Technical Memo

Subject: 118th Street Alignment Study
(TS.2019.118STA) RFP# 12-19-AB

**118TH STREET
ALIGNMENT
ALTERNATIVES**

118TH STREET
PREFERRED ALTERNATIVE
PLAN VIEW

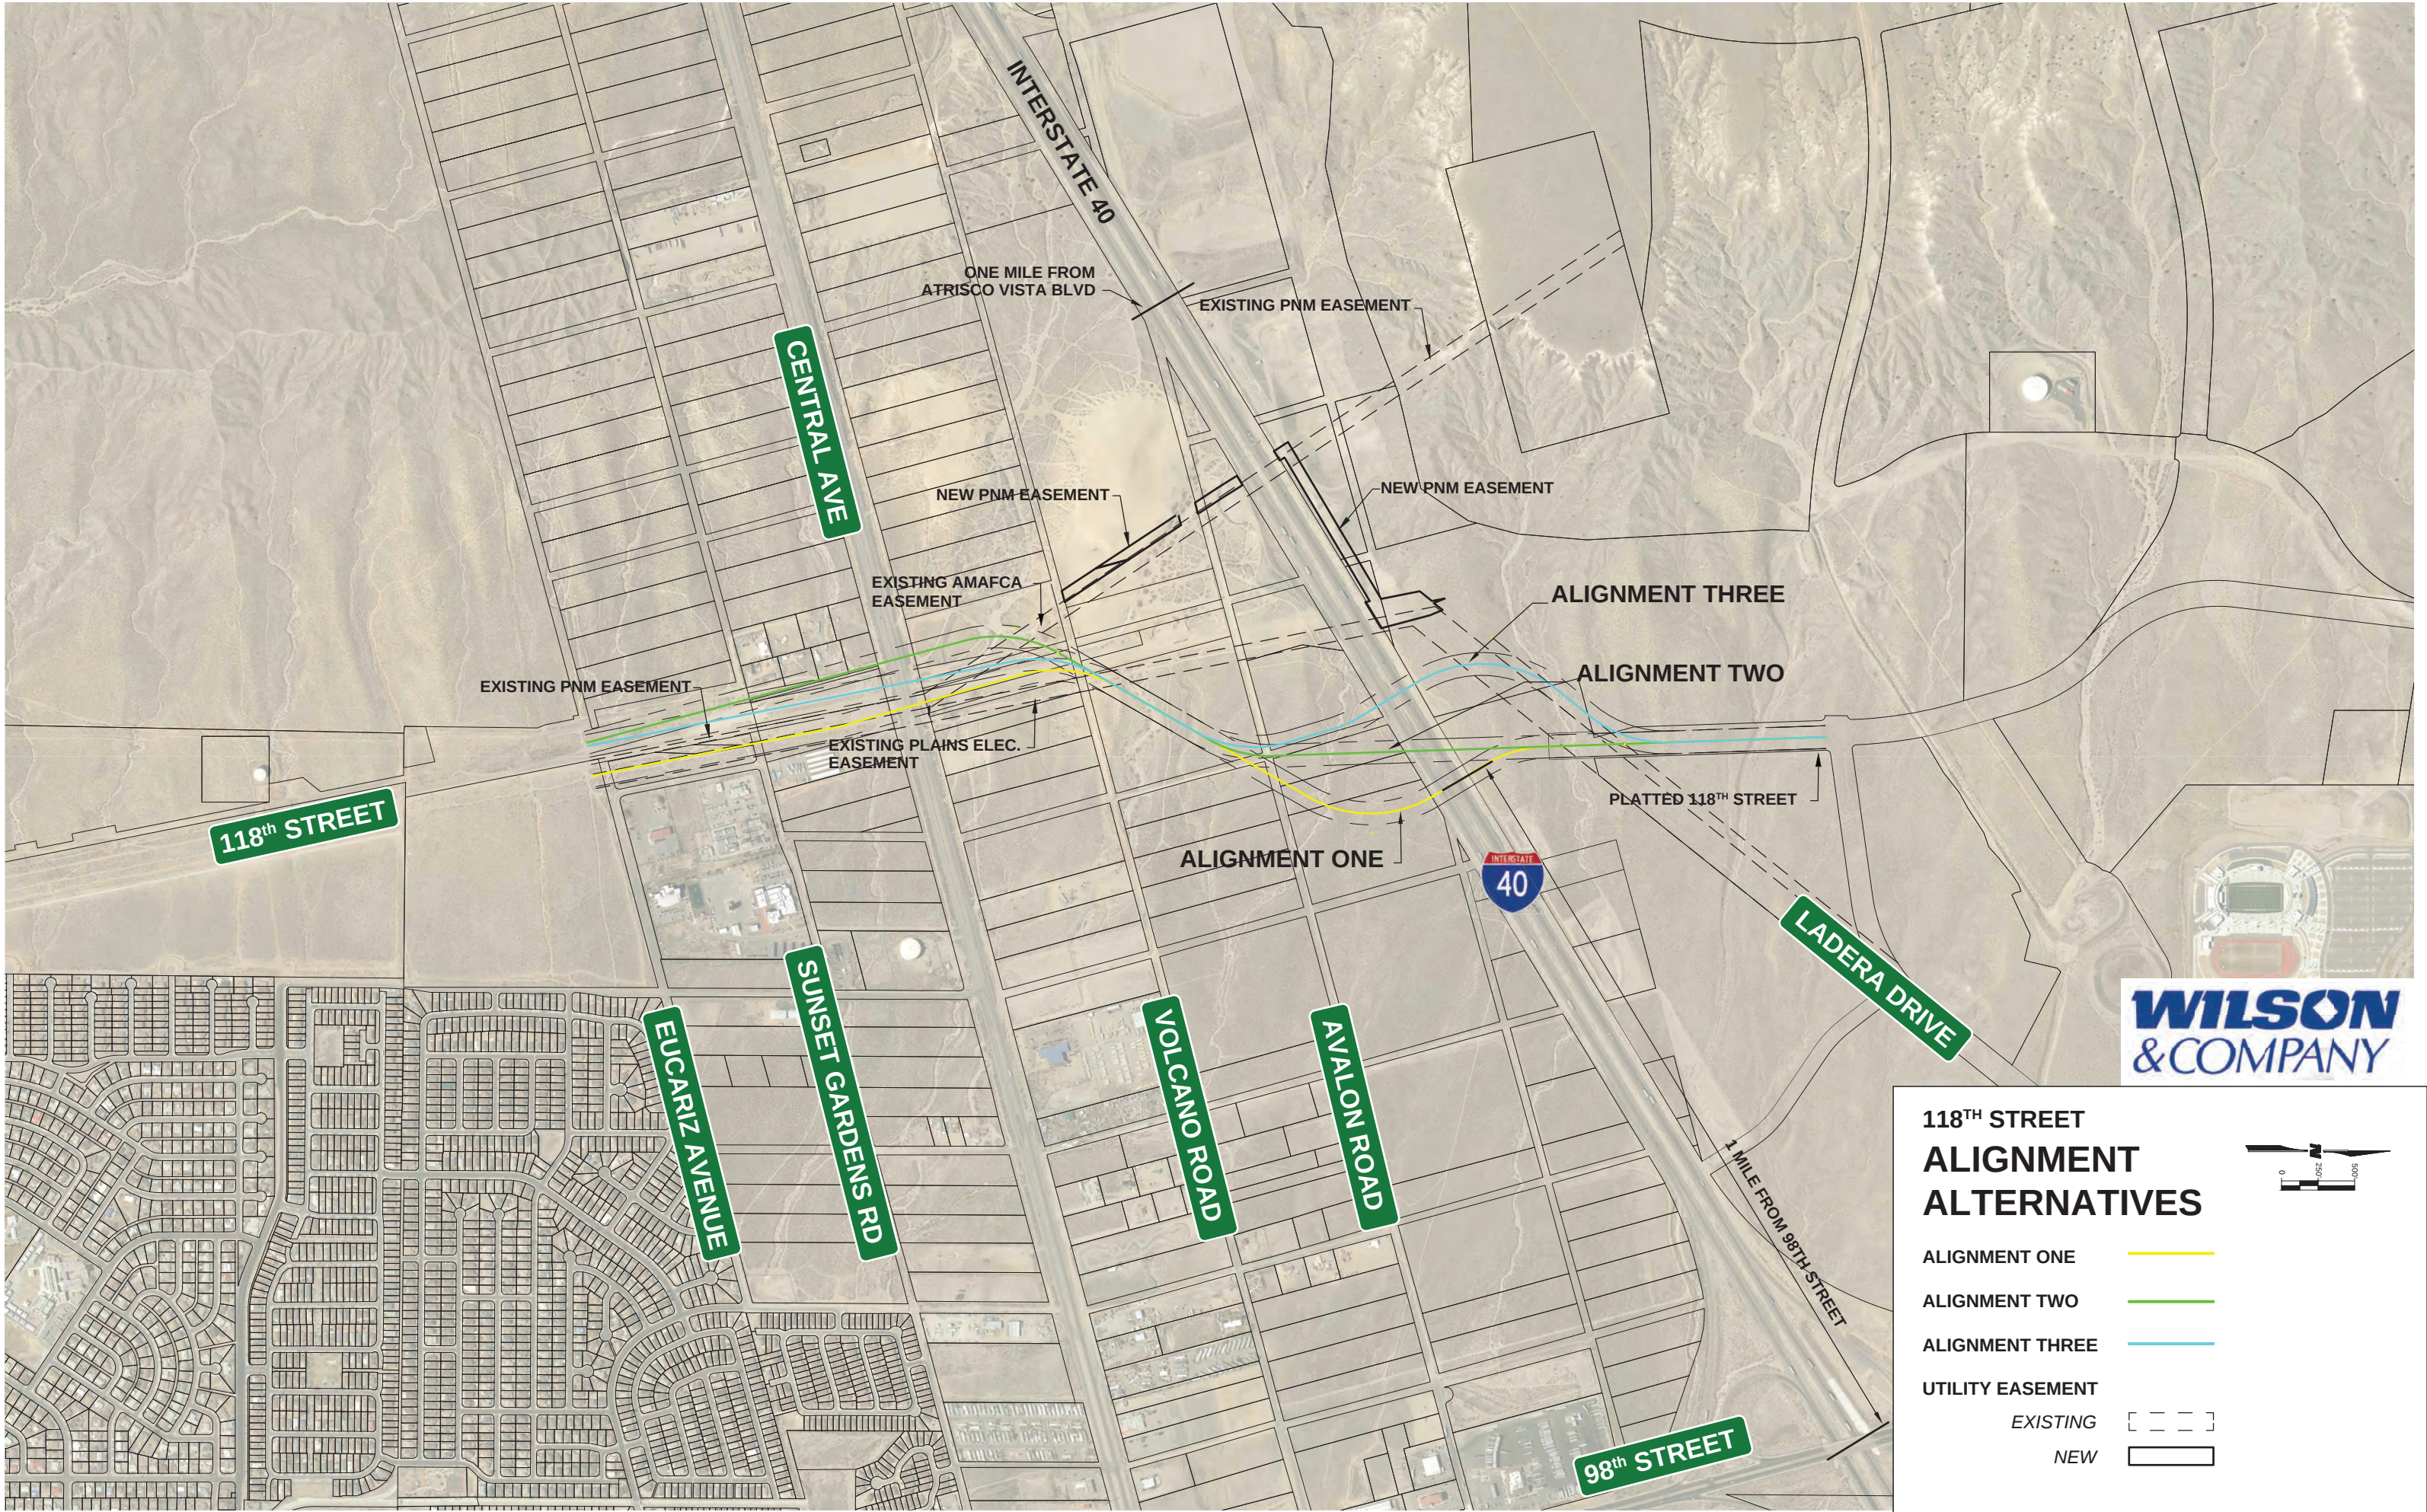
- A display of three alternative alignments was presented to the group and discussed.
- Each alignment includes the 156' ROW footprint required for the typical section.
- Plains Electric and PNM easements are shown; we do not cross PNM's new easement area.
- Alignment 1
 - Follow the current platting created by COA on the north side of the interstate
 - Located at the 1-mile marker distance from the 98th St interchange, the minimum distance allowed per NMDOT.
 - Crosses the Plains electric and PNM easements.
 - Electric lines will require relocation
- Alignment 2
 - Follows the current platting created by the COA on the north side.
 - Crosses the interstate at a skew
 - Longer bridge required

- Will require ROW to be purchased south of Central, potential conflict with existing homes.
- Alignment 3
 - Will require COA platting revisions on the north side

- Located on top of the AMAFCA channel
- **Nancy to provide a future I-40 typical section, to be used for this project.**
- **WCI to verify COA DPM radius minimum. 1,000' minimum**

- WCI to use 50 MPH design speed, 45 MPH posted
- COA not worried about platting of the north side of I-40, this can be revised as necessary
- WCI to determine a best fit of all 3 presented alternatives

- Maintain the 1 mile distance from other interchanges, as best as possible
 - Use 6% max grade on all on and off ramps
- On the south side of the interstate

- Look into making the PNM easement the centerline of the roadway, with a 100' median
 - Verify distance PNM will require from pole to curb and gutter
 - Can place AMAFCA under roadway, expensive and becomes a sediment trap.

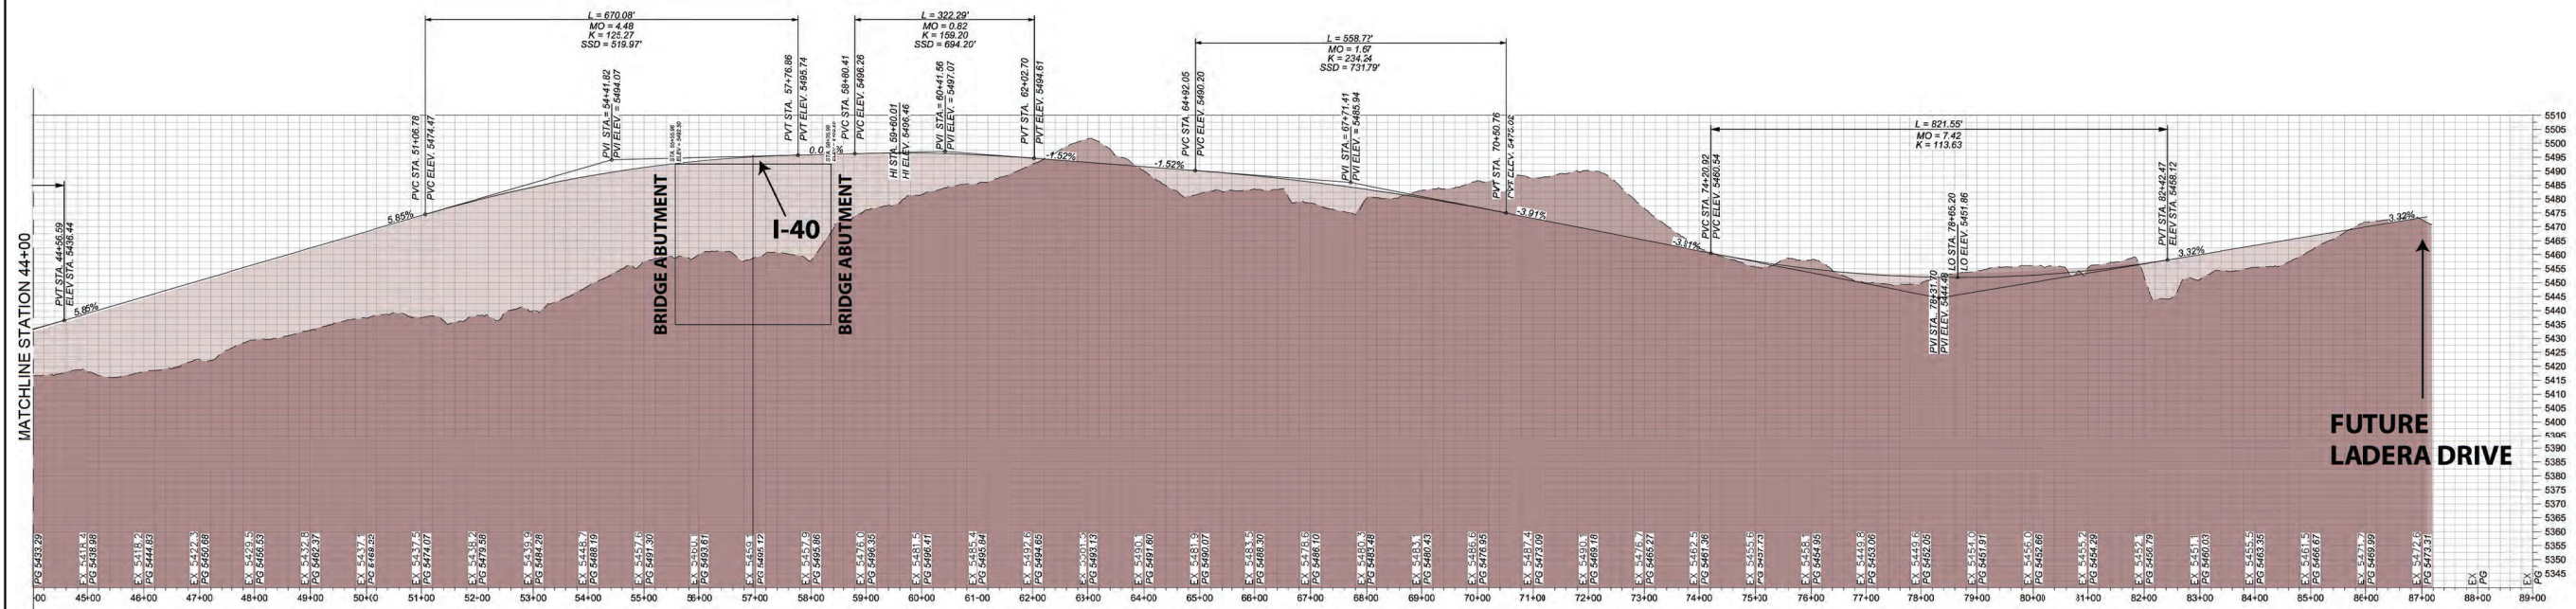
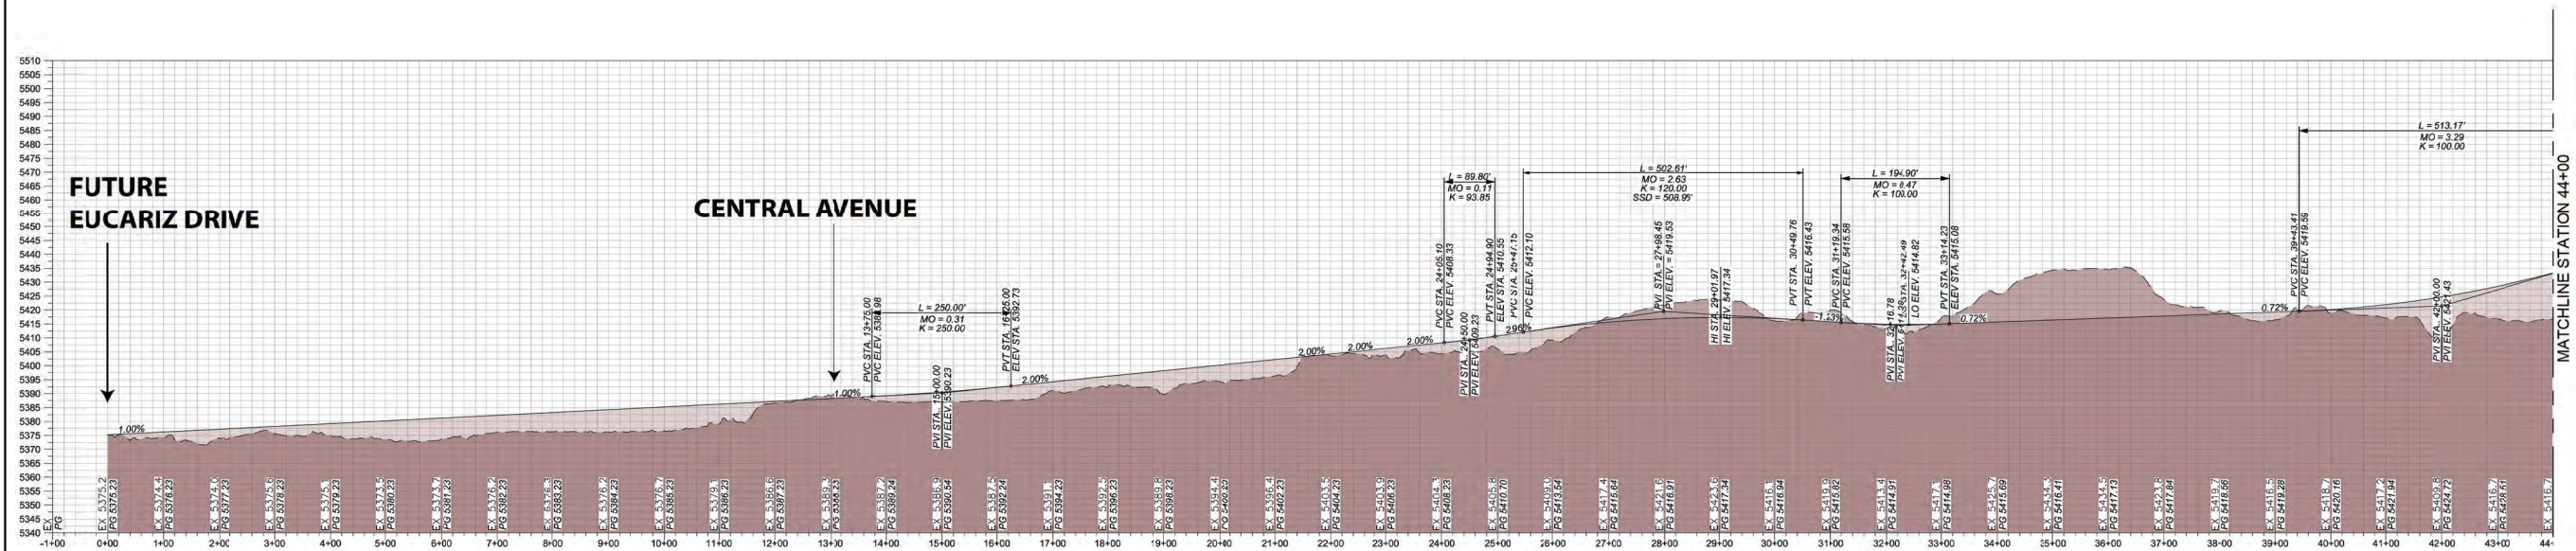
- A display of the preferred alternative alignment was provided for the group to review and discuss.
- NMDOT comments
 - Okay with the 16 degree skew and the ramps outside the 1-mile marker from the 98th Street interchange. This will be reviewed and approved in the future by NMDOT and FHWA when design of the interchange takes place.
 - Process for the interchange would require a Phase IA/B study in order to get an approval.
 - Widening of I-40 to be within the existing median. **WCI to revise the I-40 layout.**
 - **WCI to try to fit I-40 improvement within the existing right of way**
- COA comments
 - The City has no plans with design in the area north of I-40

- Only the platting has been completed in this area.
 - If re-platting is required, this can be done during design
- AMAFCA comments
 - Okay with the preliminary alignment
 - This alignment is not affecting their infrastructure
- **WCI to update I-40 layout and provide Nancy a PDF for review and comments.**
- Once the alignment is approved by NMDOT, BernCo will meet with FHWA to discuss potential interchange needs
- WCI to look into 2 side roads for BernCo, verify where these roads will tie
 - Avalon Road and Volcano Road to be checked
 - Use 6% max grade
 - Use for future moratorium needs
 - Make sure Central Ave and 118th Street intersection is a 90 degree angle

- A display of the preferred alternative was reviewed in AutoCAD and discussed by the team.
- Based on the NMDOT SAMM, 1,300' is the distance between full access intersections.
- Avalon Road and 118th Street intersection to be a right in-right out intersection.
- Layout to include sidewalk on entire west side of roadway
- **Richard to provide side street typical sections to be used.**
- WCI to coordinate with Access Management project to ensure the 118th Street intersection is shown correctly.
- We will have one more coordination meeting with all municipalities to present the final layout.
- Technical Memo to include:
 - Appendix of all alternatives created
 - Brief description of each

- A display of the preferred alternative was reviewed in AutoCAD and discussed by the team.
- Bernco, COA and NMDOT agree on the preferred alternative alignment.
- WCI to move forward with Technical Memo and finalize project.
- BernCo would like the following items included:
 - Isolate the ROW and slope limit layers and provide in separate .kmz files
- WCI to update profile to include proposed grades
